RO QUICK GUIDE OVERVIEW

The **WL400 Water Treatment System** contains a high capacity Reverse Osmosis Filtration System installed in the Base Cabinet.

REPLACING RO MEMBRANE

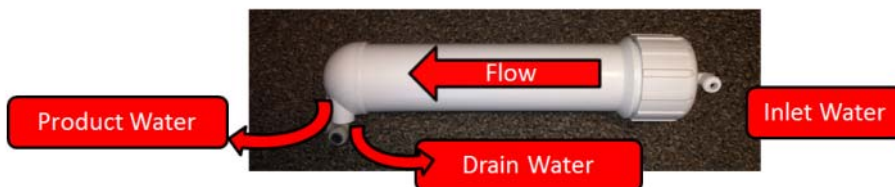
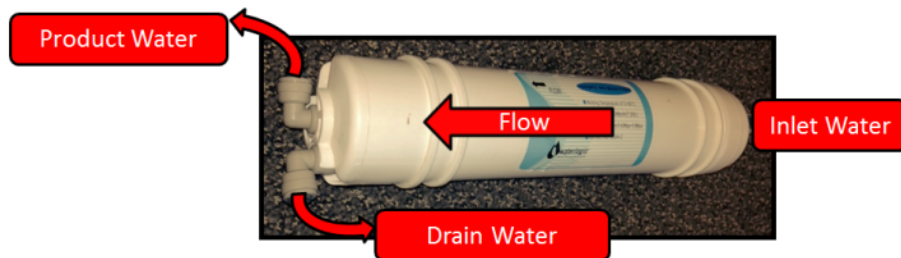
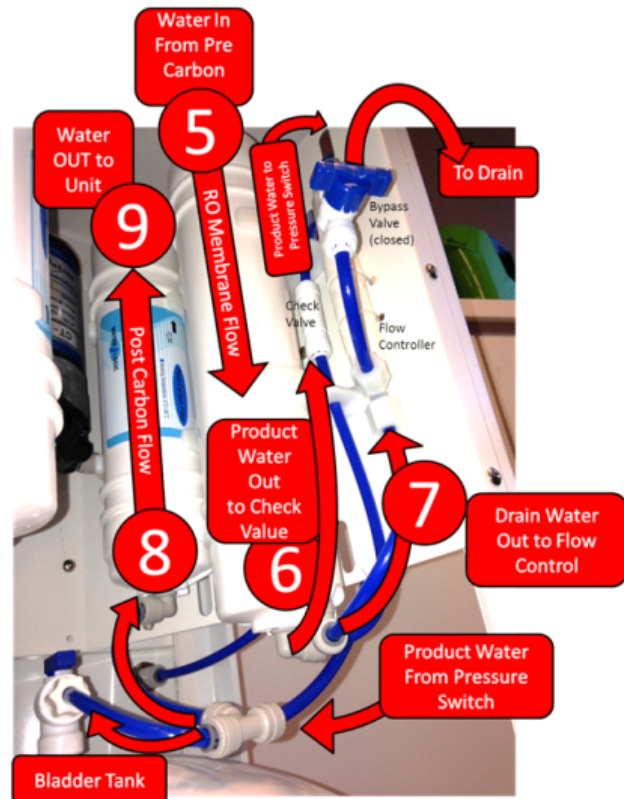
Original RO Membrane

WLCP PN 10-8060 (Factory PN RO-0004C)
 One Piece 100 Gpd (378.5 Lpd) RO Membrane

NEW RO Membrane Kit – P/N 10-8061

Kit 10-8061 consists of:

Quantity	WLCP Part No	Description
1 each	15-3001 (R-RO)	Dow Film Tec 75 Gpd RO Membrane
1 each	15-3020 (R-P001)	Ro Membrane Housing (2 piece)
3 each	JG 480821S	¼" Tube * 1/8" NPT Rigid Elbows
1 each		RO Membrane Instructions

OLD RO Membrane # 10-8060 Installed

NEW RO Membrane # 10-8061 Installed
